Technical Service Bulletin

No.JTB00039
19 April 2007

Subject/Concern: Noise From Windshield Area at High Speed

XJ Range | | VIN-range: G49701 Onwards

E93296

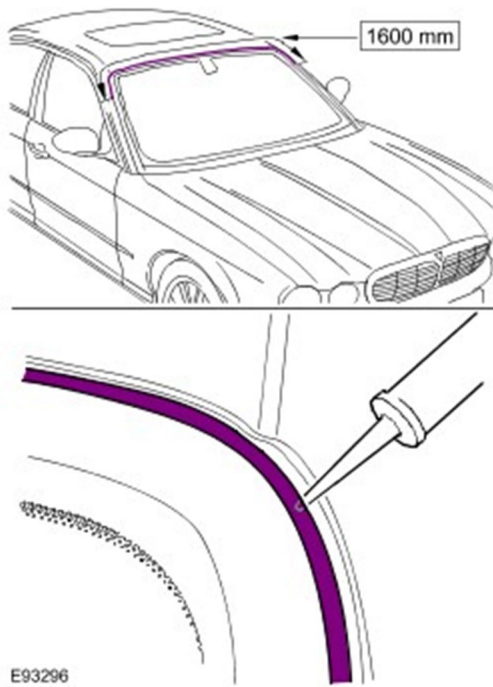
Wind or buzzing noise emanating from windshield at high speed (approximately 90 mile/h (150 km/h)).

Cause: The edge of the windshield flip seal lifting at high speed, causing the seal to vibrate in the airflow.

- 1 . Clean area behind the flip seal in preparation for the glazing compound application.
- 2 . **NOTE:** An allowance equivalent to £2.27 sterling may be claimed in local currency quoting sundry item code (ROW) ZZZ001, NAS ('other') for the 3M™ Auto Bedding and Glazing Compound 08509 (half a tube to be used per vehicle).

Apply 3M™ Auto Bedding and Glazing Compound 08509 under the flip seal to prevent vibration of the seal at high speed.
